MONTGOMERY COUNTY HISTORIC PRESERVATION COMMISSION
STAFF REPORT

Address:	7314 Maple Avenue, Takoma Park	Meeting Date:	10/8/2025
Resource:	Contributing Resource Takoma Park Historic District	Report Date:	10/1/2025
Applicant:	Eric Maier and Krisztina Petz (Eric Hurtt, Architect)	Public Notice:	9/24/2025
Review:	HAWP	Tax Credit:	No
Permit No.:	1129183	Staff:	Laura DiPasquale
Proposal:	Construction of new addition and retroactive tree removal

Figure 4: The proposed front elevation showing the addition projecting beyond the northeastern wall plane of the historic house.

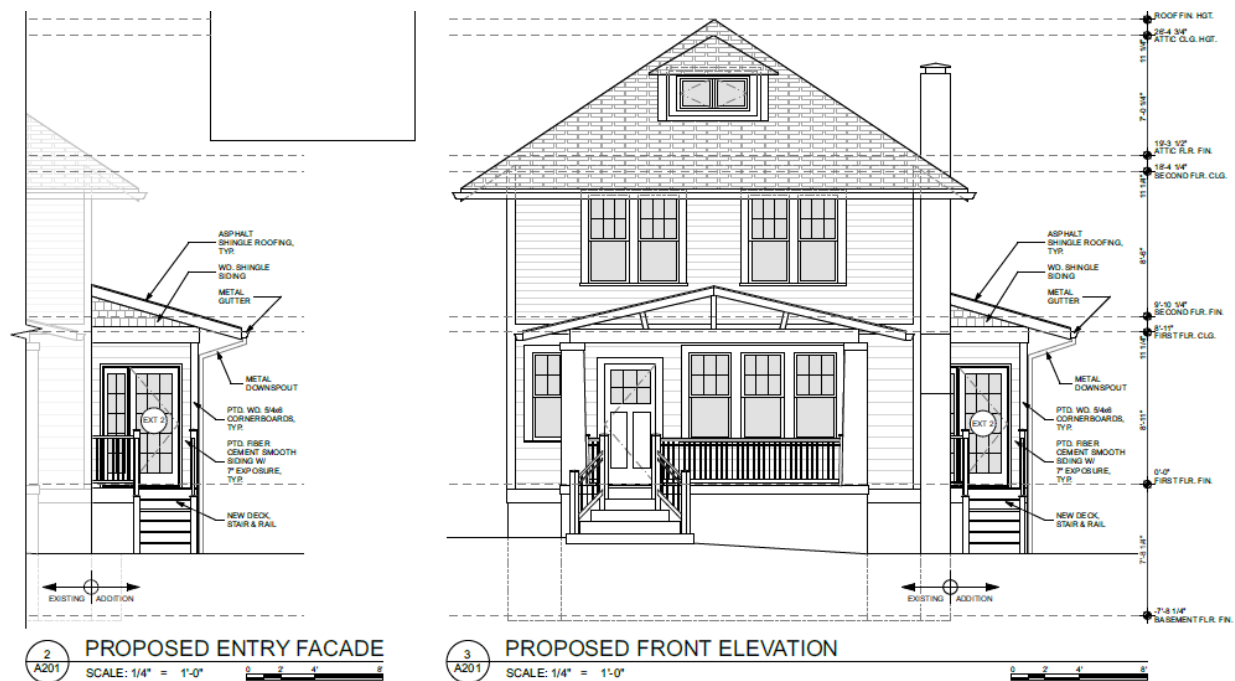
- The front elevation of the proposed addition should be pulled back behind the cornerboard of the main block.
- The overhanging eaves of the proposed addition should be reduced to the extent possible. It is acceptable for there to be a slight overhang of the roof onto the side elevation of the main block intersecting with the cornerboard.

Figure 5: The proposed first-floor plan from the preliminary consultation review (left) and HAWP (right).

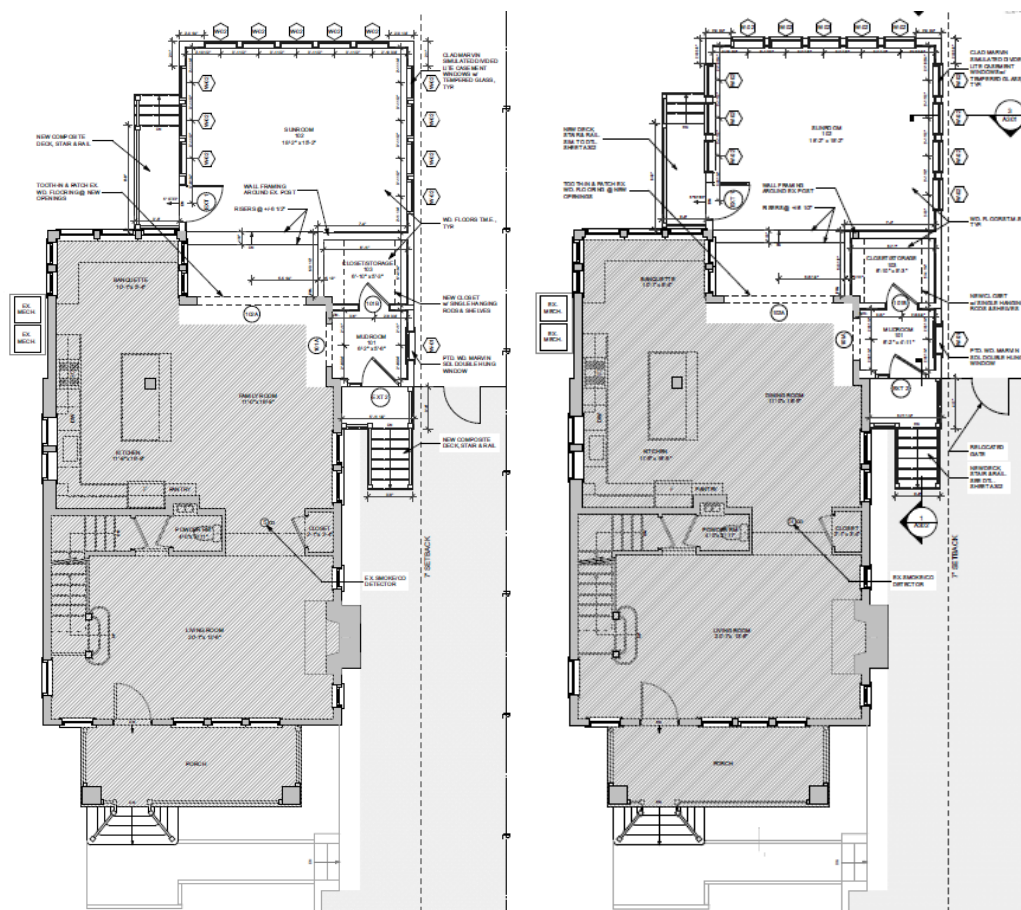
Staff finds that the applicants have responded to most of the feedback from the HPC during the preliminary consultation review. For the HAWP submission, the applicants have revised the addition to pull the front elevation of the addition behind from the rear wall plane of the main block, reduced the eave overhang by 6 inches (from 3-feet to 2-feet 6-inches), and supplied supplemental drawings requested by the HPC, including existing conditions drawings, a full elevation detail of the proposed addition unobscured by the existing chimney, and complete materials specifications.

Figure 8: Proposed stair, landing, and railing detail (left), and example photograph of Acre composite decking with edge board installation. Staff notes that the edges of the boards are exposed in the proposed detail, and recommends a finished edge be added to the treads and landing.

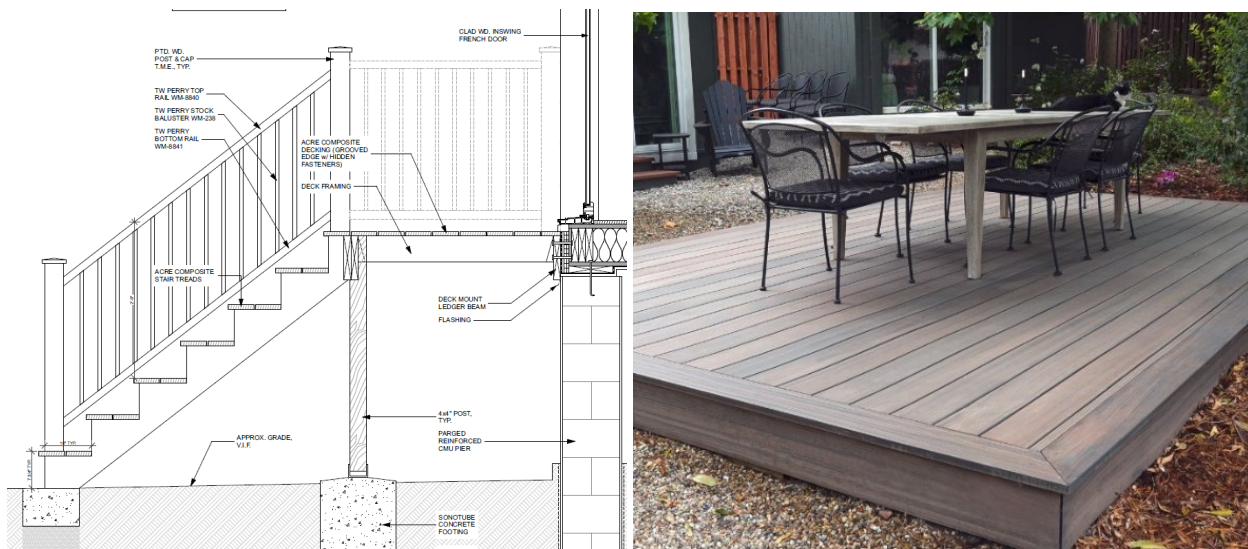
property unimpaired. Staff finds that the proposed 7-inch exposure Hardie plank siding, simulated-divided-light clad-wood Marvin windows, and asphalt shingle roof are compatible with the historic structure and surrounding streetscape, as well as the HPC's 2015 approval for siding installation on the main block and new addition, and are consistent with the *Guidelines* and Chapter 24A-8(b)(2). Since the preliminary consultation review, the applicants have included additional material specifications for the composite decking and stair treads, which are identified as Acre, and wood railings. Staff finds that the Acre composite decking meets the requirements for a compatible substitute material set forth in *Policy 24-01*, but that the detail drawing shows that the edges of the boards will be exposed on the northeast side. Staff recommends that a finished edge board be added to the landing and stair treads to create the appearance of a cut solid board.

1. The composite decking and stair treads must have solid edge boards.
2. The eave overhang of the proposed addition must be reduced to a maximum of 16 inches.
3. The applicants must plant one large species shade tree on the property.
4. The applicants must submit a complete tree survey by a certified arborist or the Takoma Park arborist identifying the locations, dimensions and species of all trees greater than 6 inches d.b.h on the subject property and confirmation that the proposal will not negatively impact any mature trees.

Figure 10: Proposed front and rear elevations submitted for the HAWP. Staff finds that there is no noticeable reduction in the proposed eave overhang.

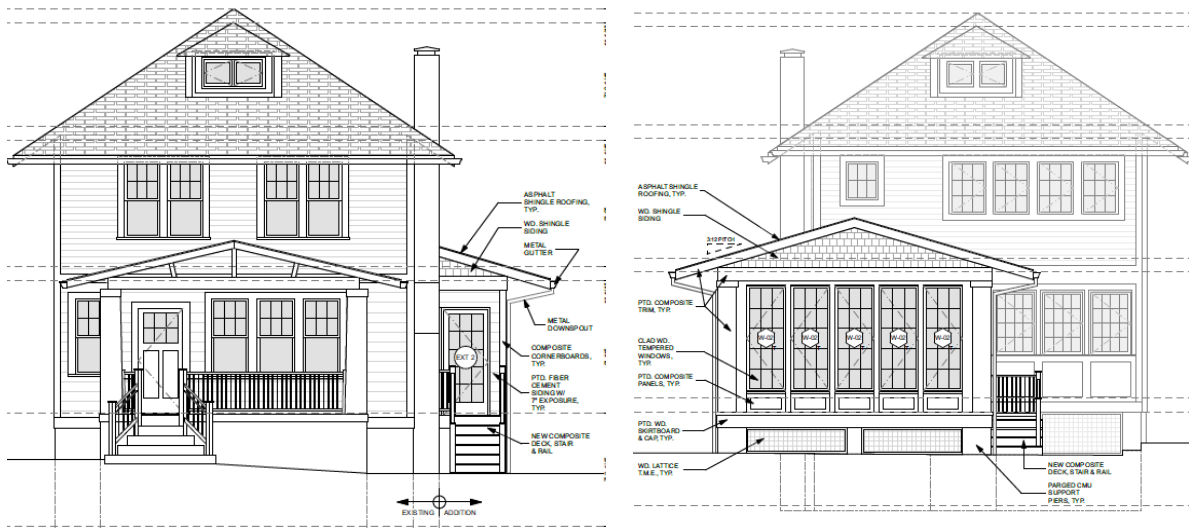
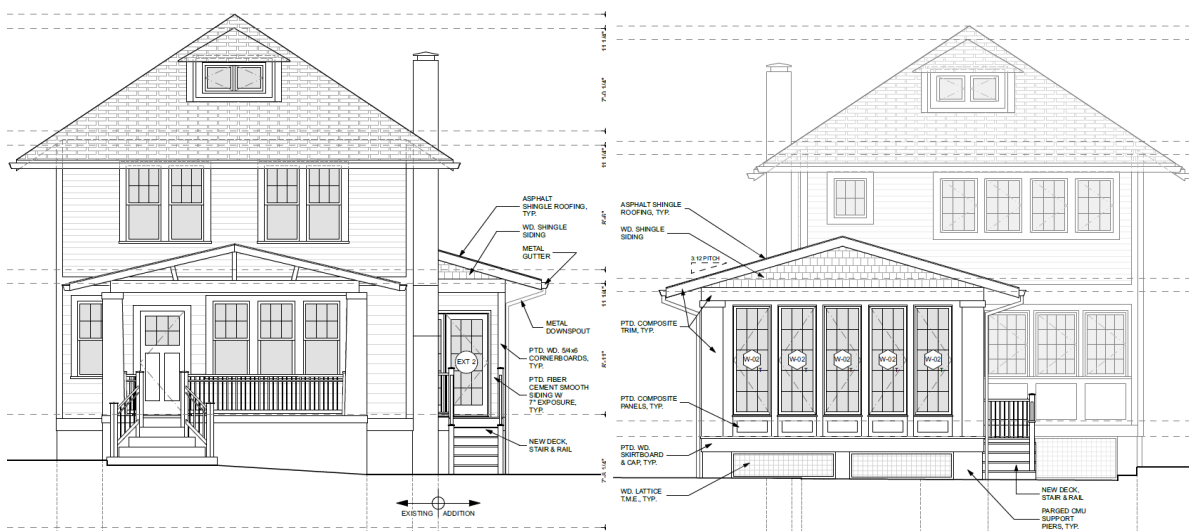
Staff continues to find however, that the proposed eave overhang is out of scale with the proposed addition and should be further reduced. Staff finds that the Commissioners present at the preliminary consultation review generally concurred with staff that the previously-proposed 3-foot eave overhang was overly large and out of scale with the proposed addition. For the HAWP submission, the applicants have only reduced the overhang by 6 inches, from 3-feet to 2-feet 6-inches, citing Commissioner Hains' comments at the meeting, in which he stated:

Staff finds that that an eave overhang that is over 40% as wide as the projection of the addition beyond the wall plane of the historic house remains out of scale with the proposed addition. Staff finds that the addition should read as secondary to the main block and not try to replicate the overhanging eave depth of the main block, which has a different pitch and massing, and should be differentiated from the old, per

Standard 9. Staff recommends that the overhang be reduced to a maximum of 16 inches.
